McMullan & Associates, Inc.

M&A 3575-1

RE: Headquarters Road Bridge

Figure 1 - PROPOSED REHABILITATION SECTION

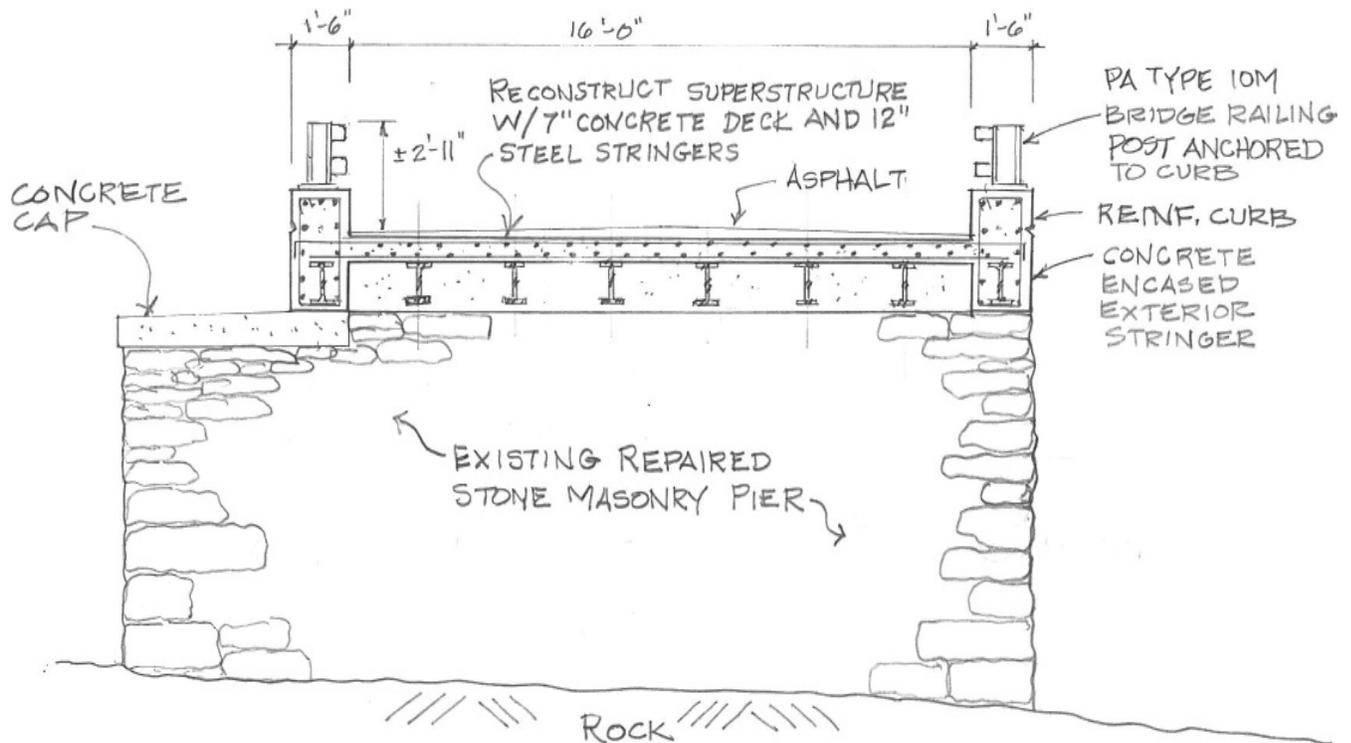
The proposed **Rehabilitation** of the bridge would be composed of the following elements:

1. Repair the existing Stone Masonry Piers and Abutments and improve the existing scour countermeasures using approved materials and techniques. This would preserve key features "... that convey historical, cultural or architectural values".
2. Replace the existing deteriorated concrete deck and steel stringers with a new concrete deck and steel stringers similar in spacing and appearance that is capable of supporting HS-20 and Emergency Vehicle loading.
3. Reconstruct portions of the stone masonry wing walls using the original stones. The location of the wing wall at the northwest corner of the bridge will be adjusted to accommodate wider vehicular turns.

Figure 2 - **PROPOSED REPLACEMENT SECTION** by PENNDOT

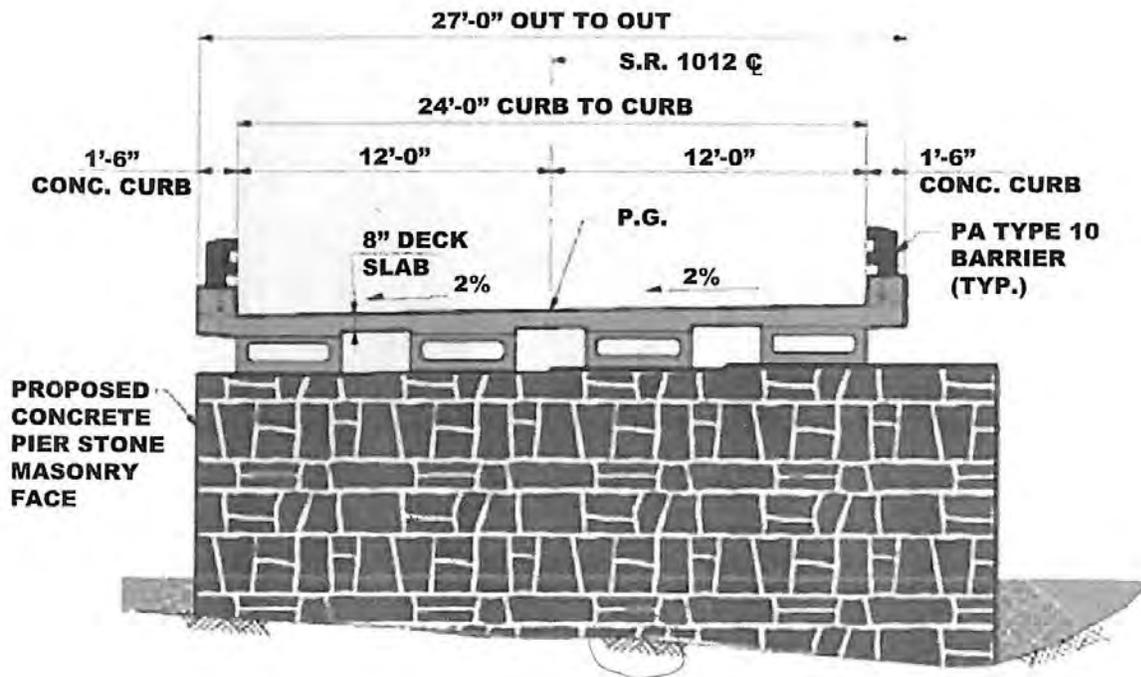
We reviewed the April 27, 2011 Public Plans proposed by PennDot for the **Replacement** of the bridge as prepared by Urban Engineering, Inc. These plans contain several elements that are in direct conflict with the Secretary's Standards as follows:

1. The proposed replacement of the existing stone piers, abutments and walls with new reinforced concrete construction with fake stone masonry facing does not meet the Secretary of Interior Standards. The Standards state "...changes that create a false sense of historical development, such as adding conjectural features or elements from other historic properties, will not be undertaken."

2. The proposed replacement of the existing steel and concrete deck superstructure with precast concrete box beams is contrary to the Secretary of Interior's Standards "...Where the severity of deterioration requires replacement of a distinctive feature, the new feature will match the old in design, color, texture and, where possible, materials."

3. The proposed width of the bridge roadway of 24 feet drastically changes the character of the span and does not comply with the Secretary's standard "...The historic character of a property will be retained and preserved. The removal of distinctive materials or alteration of features, spaces and spatial relationships that characterize a property will be avoided."
